Engineering Change Request		ECR Number	R10516W
Initiator:	Max.Ma	Date:	2026.07.28
Part number description			
Item	K3 Code material part numbers	Drawing/ Doc Number	Version of current related document
1	GEN2 600A CCS1 plug series	All part number drawings, see attached list.	/
2	GEN3 600A CCS1 plug series	All part number drawings, see attached list.	/
3	GEN3 600A NACS plug series	All part number drawings, see attached list.	/
Reason of change: ☐ Customer requirement (list the feasibility analysis of customer specification: _____) ☐ Supplier request (list the PCR number: _____) ☒ Internal improvement ☐ corrective ☐ other Please describe here in detail: 1. Install an SR at the gun-cable joint to prevent over-bending during field use. 2. UL certification has been filed.			
Change level and impact assessment (Please tick in the appropriate position)			
Change level	Change content	Concerned area(Shenzhen, Hermosillo, Chennai)	Whether to notify the customer

Engineering Change Request		ECR Number	R10516W
Initiator:	Max.Ma	Date:	2026.07.28
Part number description			
Item	K3 Code material part numbers	Drawing/ Doc Number	Version of current related document
1	GEN2 500A CCS2 plug series	All pa

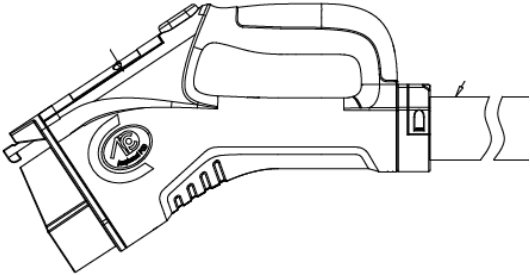
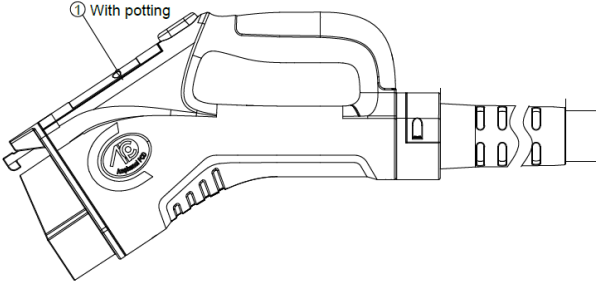
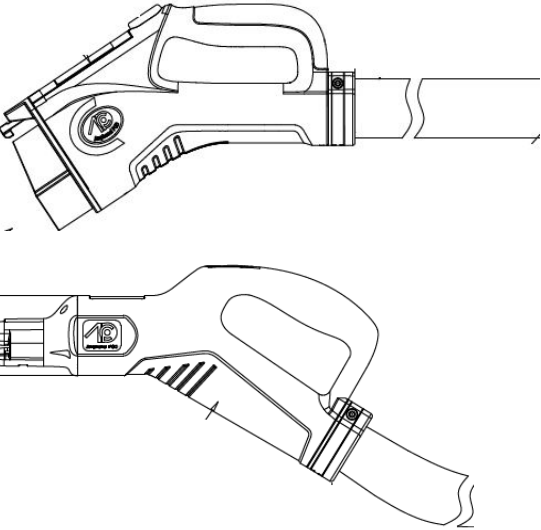
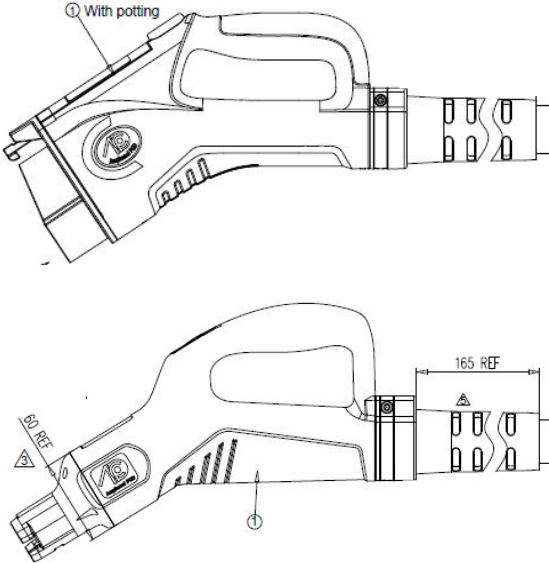
Before change 1. CCS2 : Gen2 Without SR and Rib  2. CCS2: Gen3 Without SR 		After change 1. CCS2 : Gen2 With SR and Rib  2. CCS2: Gen3 With SR 	
Disposition of old materials ☐ Rework ☒ Use as it is ☐ scrap ☐ Other (please describe): _____ ☐ N/A		Expect date to switch to new material <u>2026.09.30</u>	
Approval by the supervisor of requester.: <i>Ben</i>		Approval by the head manager of the request dept.: <i>Cheng Huang</i>	
Customer approval: ☐ Approved ☐ No approved ☐ Conditional approval (please describe) : Signature: _____ Date: _____			
Remark:

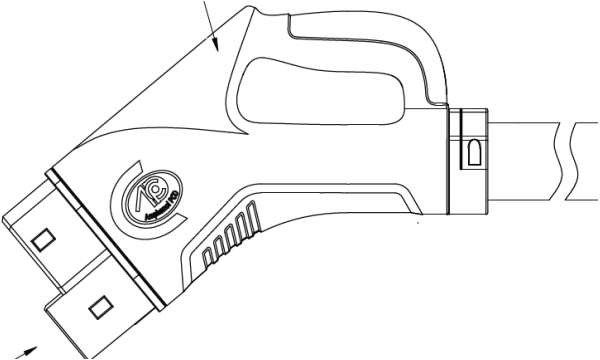
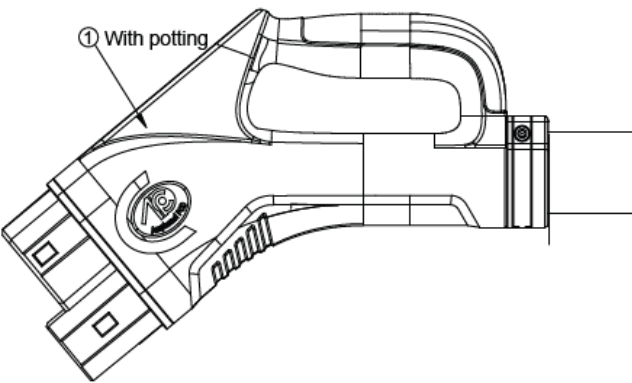
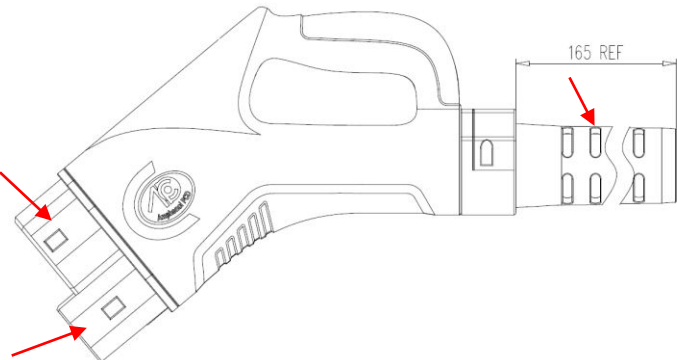
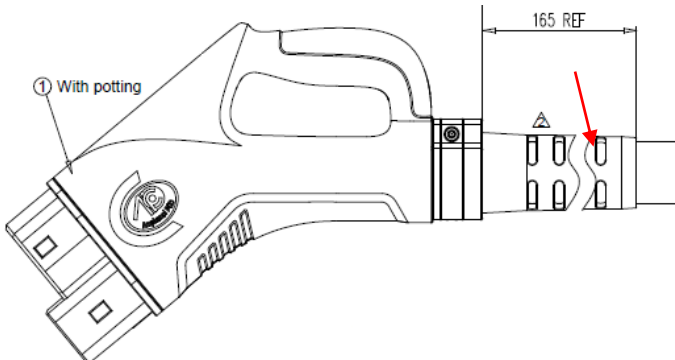
Before change 1.CCS1 : Gen2 Without SR 		After change 1.CCS1 : Gen2 With SR 	
2. CCS1 NACS: Gen3 Without SR 		2. CCS1 NACS: Gen3 With SR 	
Disposition of old materials ☐ Rework ☒ Use as it is ☐ scrap ☐ Other (please describe): _____ ☐ N/A			Expect date to switch to new material <u>2026.09.30</u>
Approval by the supervisor of requester.: <i>Ben</i>		Approval by the head manager of the request dept.: <i>Chinghung</i>	
Customer approval: ☐ Approved ☐ No approved ☐ Conditional approval (please describe) : Signature: _____ Date: _____			
Remark:
